# Northgate Apartments Phase II

RECOMMENDATION MEETING  
AUGUST 26, 2019  
PROJECT #3030779-LU

SUMMARY OF RESPONSES

BOARD COMMENTS - MASSING:

RECOMMENDATION: VIEW OF NORTH FACADE ALONG EASEMENT

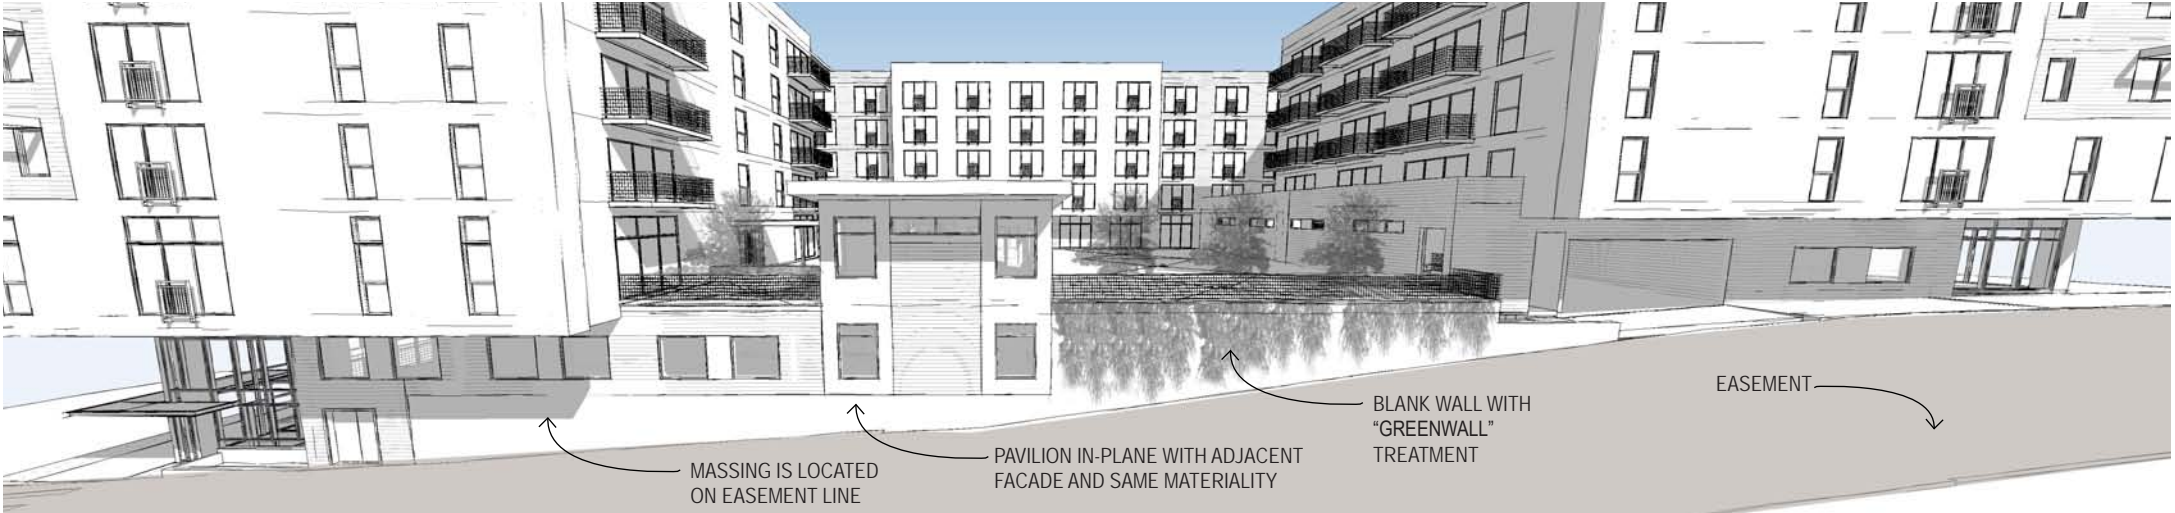
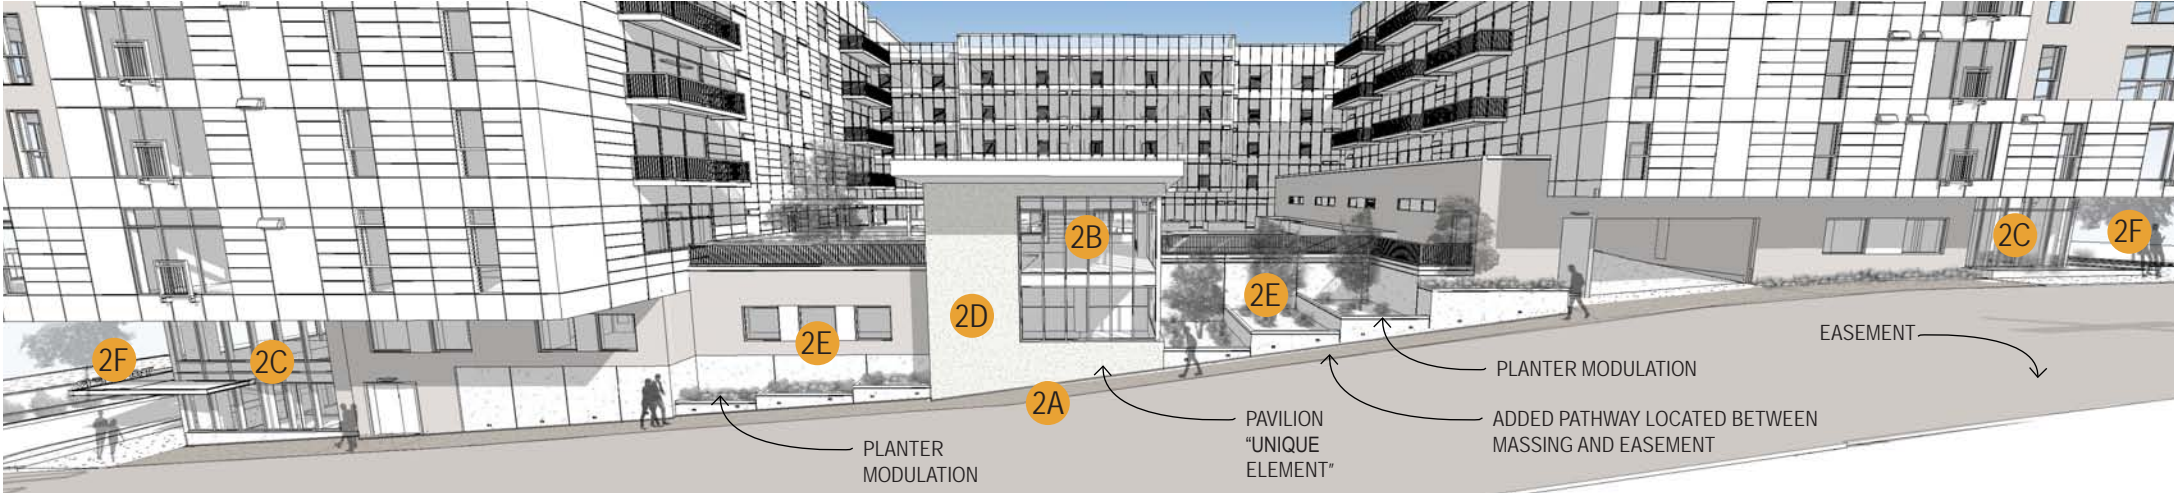
- 2A: The Board discussed the applicant's preferred site plan which provides pedestrian access only on the north side of the access easement and the additional option studied which includes a sidewalk on the southern side of the easement. The Board agreed that the sidewalk on the north side of the easement wasn't necessarily successful and expressed majority support for providing a sidewalk on the southern side of the access easement. (PL1-B, PL1-II)

- 2B: The Board supported the rearrangement of interior uses along the easement and agreed that this programming and activation should be maintained as the sidewalk along the south side of the easement is included. (PL3-II)

- 2D: The Board provided guidance to further develop the pedestrian character of the easement through textured, high quality treatment of the building face. The Board agreed that a green wall was not likely to be a successful solution in this location. (PL3-I, DC2-B2)

RESPONSE: A pathway to the South of the easement along the Northern edge of the building has been incorporated into the proposed massing. The lower massing along the entire façade has been setback from the easement line in order to provide a pathway. In addition, major massing modulations have been incorporated into the lower massing to erode the courtyard walls and bring landscaped areas to eye level from grade for enhancement of the pedestrian experience. A walking surface is provided from 5th Avenue NE to the East Lobby entrance. The pathway will be immediately adjacent to the brick massing of the Amenity Pavilion and the concrete wall at the East end of the site. The façade along the pathway is eroded away at each side of the Amenity Pavilion to bring down the scale of the building and provide landscaping interest.

RESPONSE: The project proposes to place active amenity spaces along the easement. At the East end, a double height lobby is proposed which engages the North-South pedestrian pathway and looks out directly to the easement area to the North. This double height space has an internal overlook from the second floor which provides additional interactions between the exterior ground level and interior spaces. The first story is entirely exposed at the East lobby and full height glazing is provided, but the first story quickly becomes subterranean as the easement grade rises to toward the West. At the second floor, a fitness area is provided along the easement. This is a long and narrow interior space, placing the active uses of the room near the façade and windows. At the center of the Level 3 courtyard, an Amenity Pavilion is provided with direct views to the North and West. A portion of the fitness room occupies the Level 2 area of this pavilion modulation, also with views to the West. At the West end of the easement, the 5th Avenue lobby and leasing office have views to the North as well as toward 5th Avenue.

RESPONSE: The project proposes a varied use of materials along the easement facing façade in order to enhance the pedestrian environment. The use of a high-quality, wood textured metal horizontal siding along at the west and east lobby facades and along the level 2 story at the fitness area is proposed. The Amenity Pavilion, which is a highlight of the mid-block pedestrian experience, features brick veneer, storefront glazing, wood soffit, and exposed structural elements. To enhance the pedestrian experience and bring a human scale to the facade, lower massing setbacks are provided to create opportunities for planting areas in front of concrete walls. These planters break down the scale of the walls and provide a textured greenspace and street trees at the pedestrian level. A greenwall is no longer proposed.

RECOMMENDATION: SOUTHERN FACADE

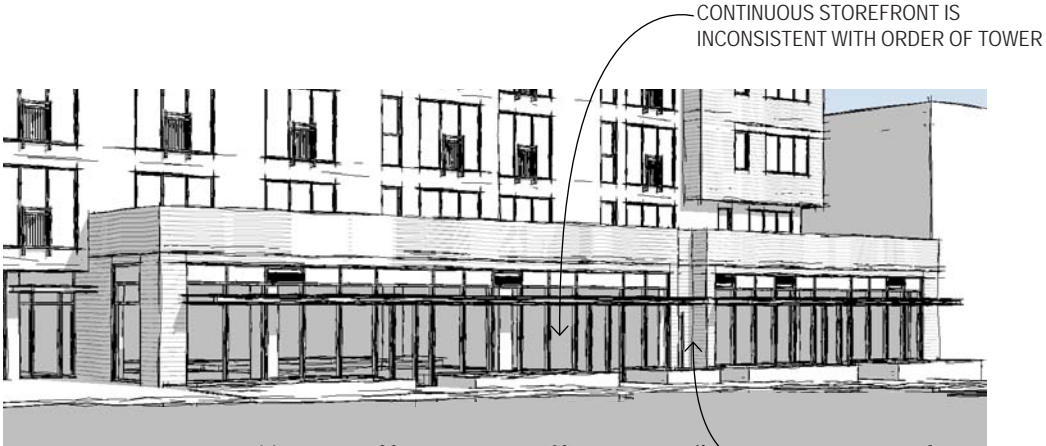
3A The Board agreed that the massing was over-articulated and provided guidance to simplify the composition and utilize a cohesive design language on all facades. The concept of creating textured insets as indicated in the precedent image on page 36 of the packet was supported. (DC2-B1)

RESPONSE: The project has simplified the overall façade composition to create a cohesive design language with refinements to these main areas: Tower secondary features and materials, Retail Frontage, and West Lobby Entry.

**TOWER SECONDARY FEATURES AND MATERIALS:** The textured corner insets and articulation remain in the proposal as supported. Below are refinements made to the overall façade composition:

- Color is consistently applied at each massing “box” to reinforce the massing gestures. The “fin” is eliminated at the courtyard to provide a clear articulation of the “box” massing.

- Colors similar to what was proposed at the EDG2 are used, though the gray is lighter and the white darkened to lessen the stark contrast allowing the overall façade to be more balanced, not favoring one massing over the other and allowing the corner modulations and materiality to dominate.

- Soffiting is proposed to match the massing above in coloring and materiality to create a clear articulation of the massing “boxes”. The gray “boxes” are lowered slightly so that a flush color transition may be avoided where massings intersect.

- Along the Southern elevation, the center bay massing is eliminated in favor of extending the length of the white “boxes”, giving the overall façade a better proportionality and the end “boxes” more significance in continuity with the Northern half of the structure. Facade interest is achieved with ordered deck stacks. A few unit stacks are without decks in order to bring additional daylight opportunities to the lower levels in this area.

RECOMMENDATION: AMENITY PAVILION MODIFIED FACADE TREATMENT AND MASSING MODULATION

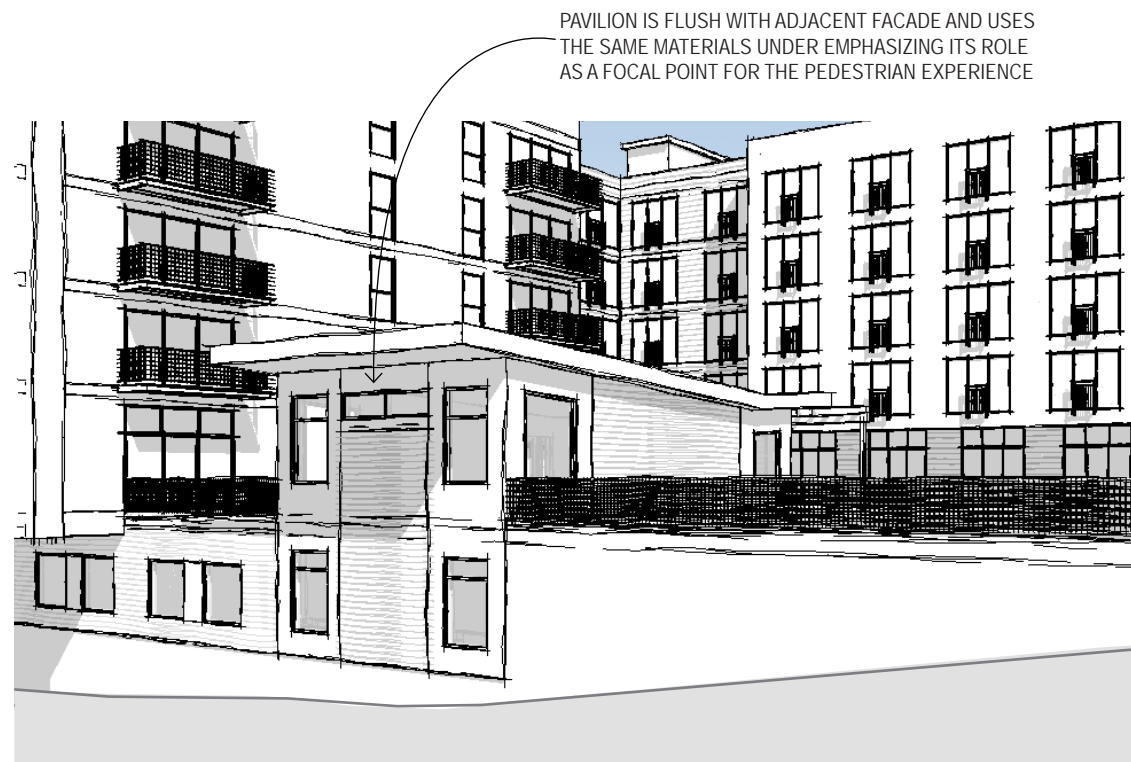
**3E** The Board provided guidance to develop a special façade treatment for the amenity pavilion within the courtyard and distinguish it as a unique element. (DC2-B1)

RESPONSE: Instead of integrating the amenity pavilion into the overall Northern façade treatment as proposed at the EDG2 meeting, a masonry material and unique glazing configuration treatment for the amenity pavilion is proposed. The massing of the courtyard to either side of the amenity pavilion is pushed south allowing the amenity pavilion a prominence, emphasizing the pavilion's unique placement and use. The lower story massing setback west of the pavilion is significant enough for the pavilion to become a major focal element within the center of the site, not only from a tenant perspective at the level 3 courtyard, but for pedestrians at the street level. This shift in massing allows the pavilion structure to gesture equally towards the north and west engaging the easement area and creating a dynamic view between the amenity uses and the pedestrian realm.

USE OF BRICK BRINGS A PEDESTRIAN SCALE MATERIAL ADJACENT TO PATHWAY

ADDED MASSING MODULATIONS EMPHASIZE PAVILION AS A UNIQUE ELEMENT

RECOMMENDATION: LARGER CORNER WINDOWS

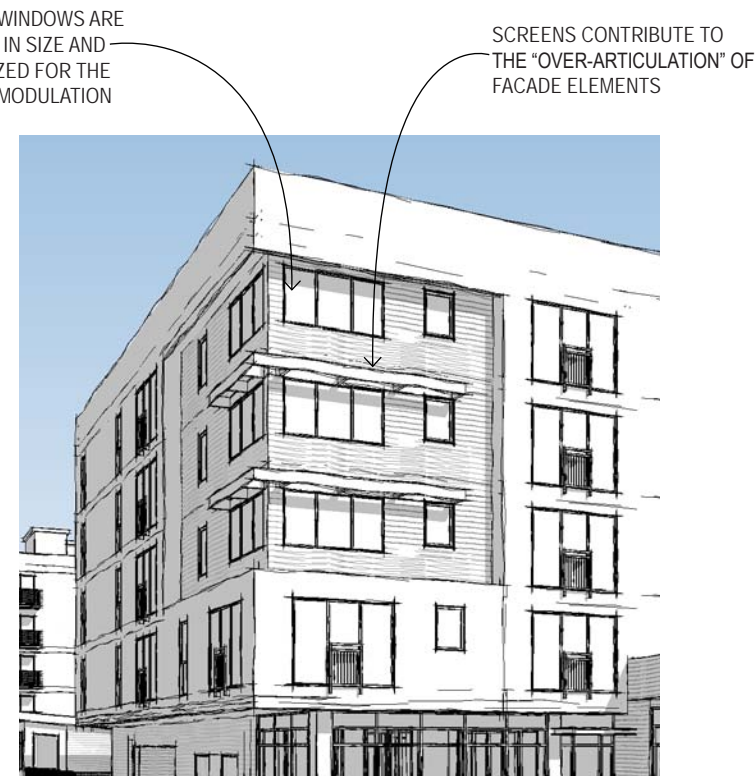
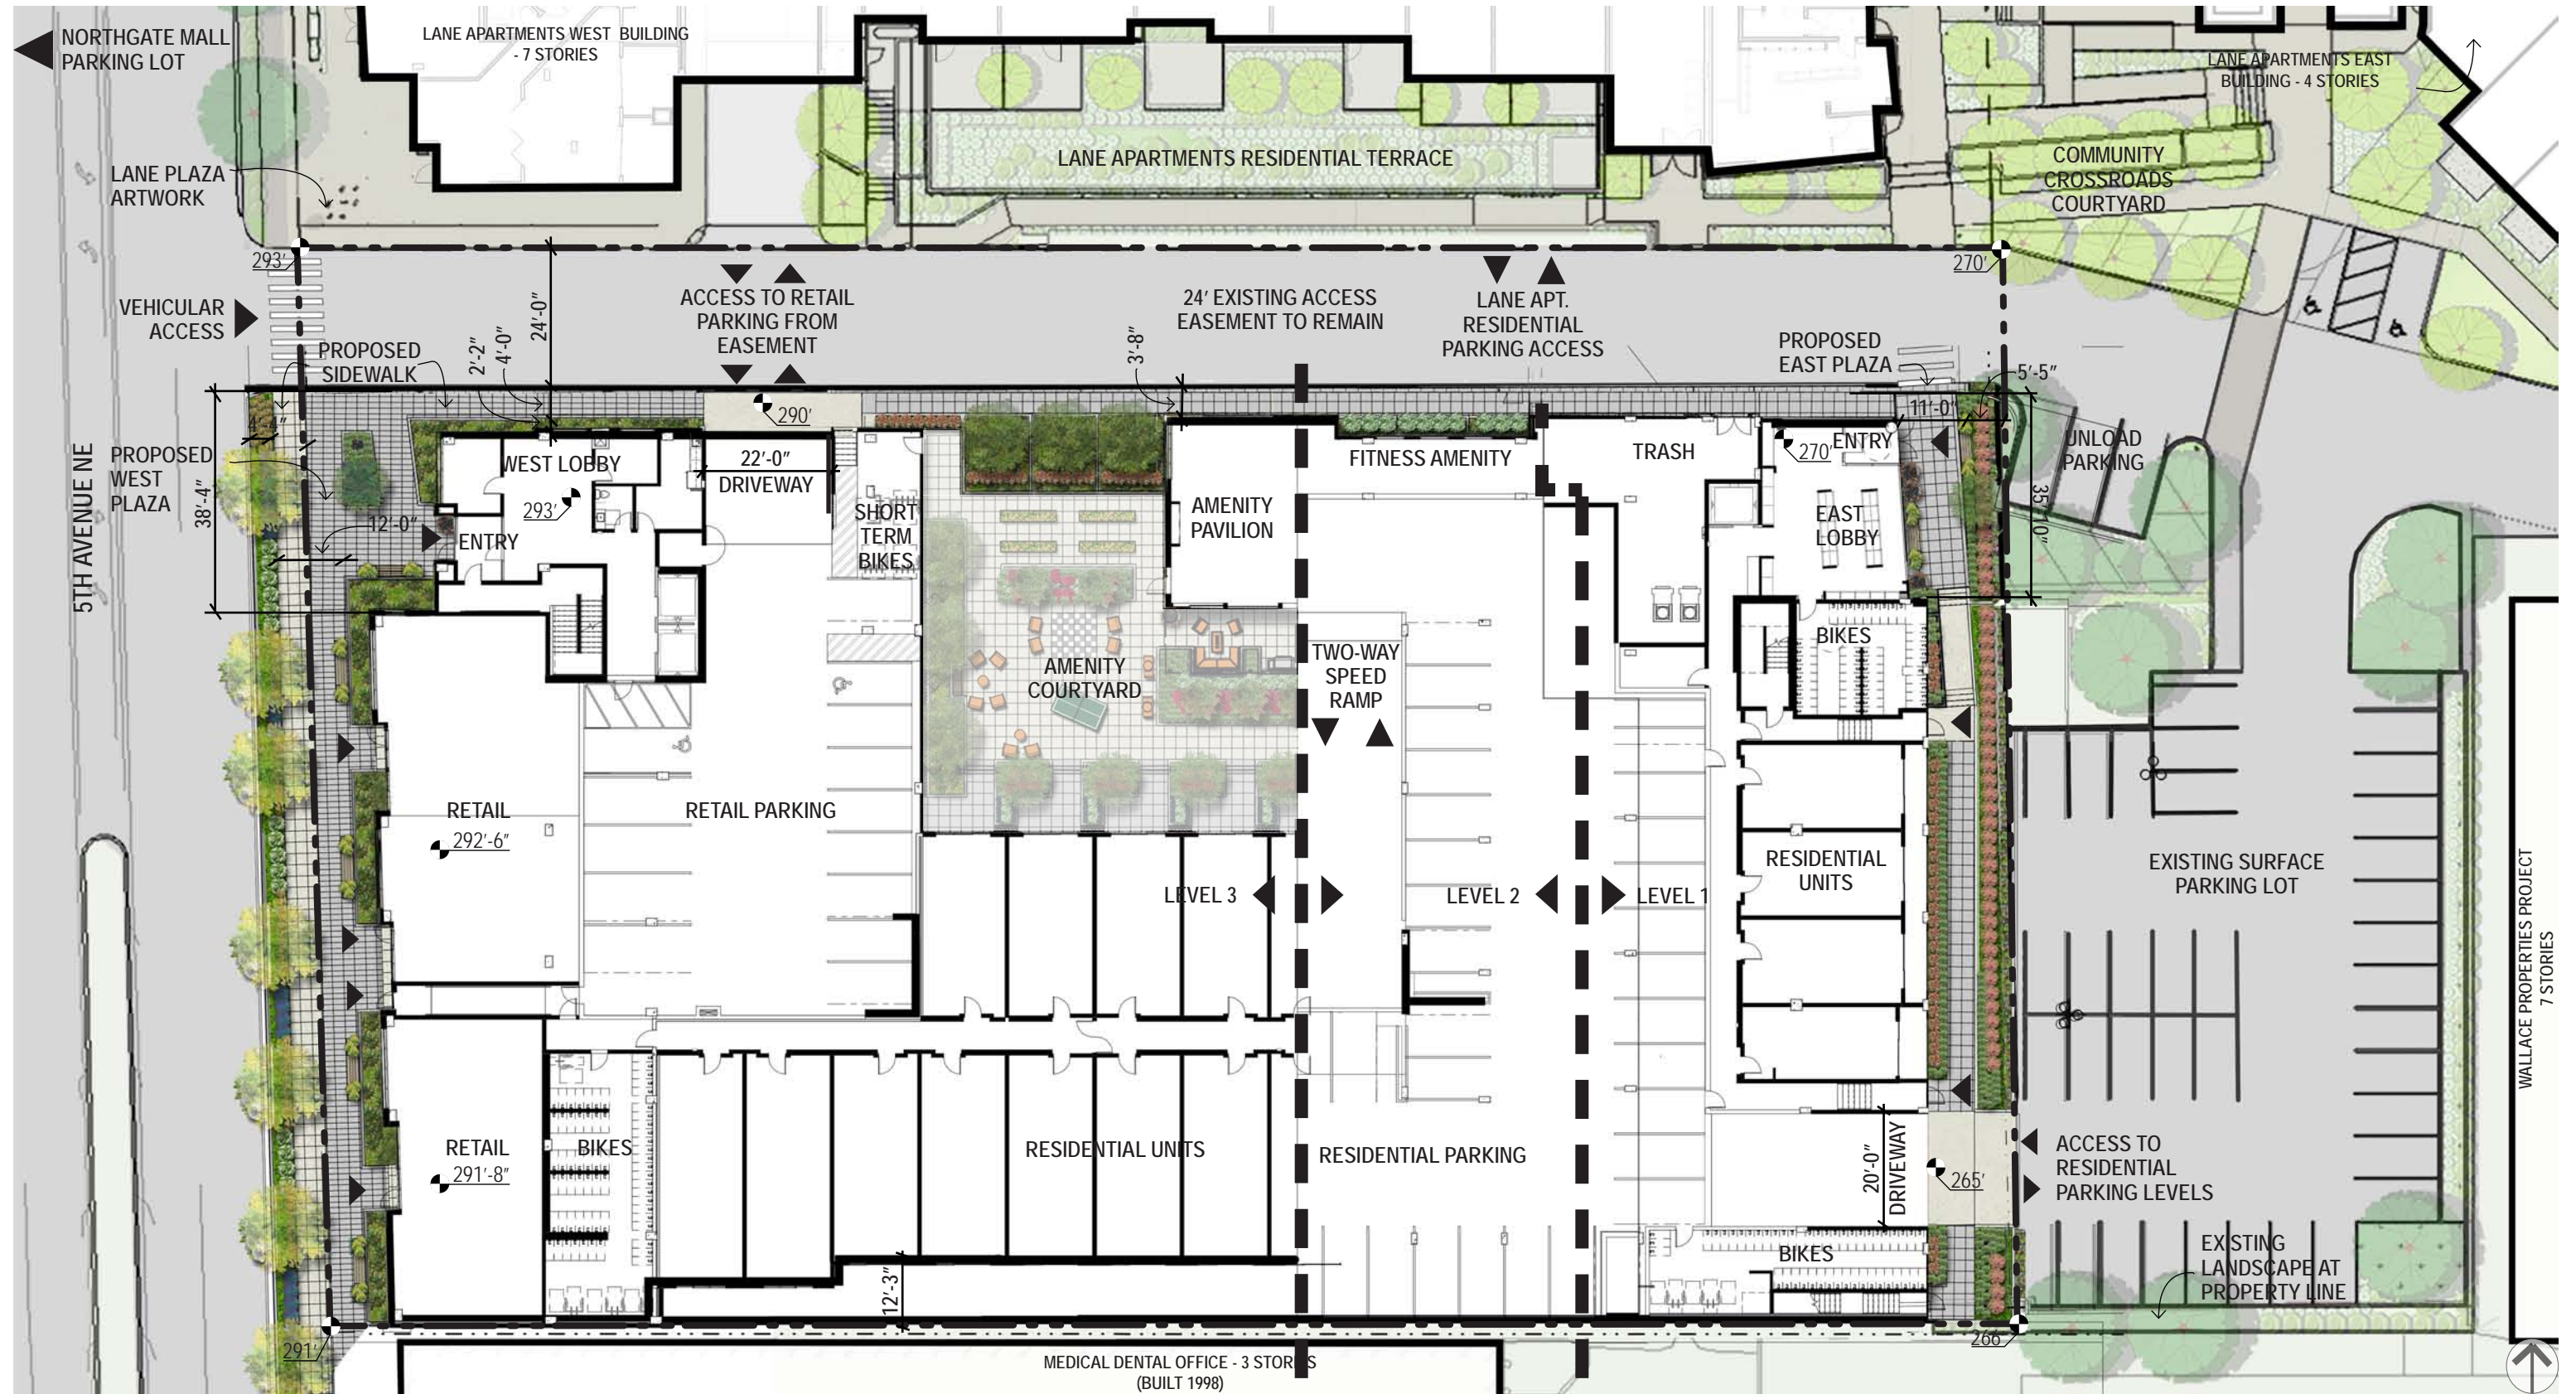
**3D** The Board recommended the use of larger windows at the building corners. (DC2-B1)

RESPONSE: Larger windows are proposed at the corners that are similar in size and styling to the main window treatments provided on the main facades contributing not only to providing additional light and air to the units but the overall façade consistency of composition.

SIMPLIFIED FACADE ELEMENTS WITH WINDOWS MATCHING THE REST OF THE FACADE IN CHARACTER AND SIZE
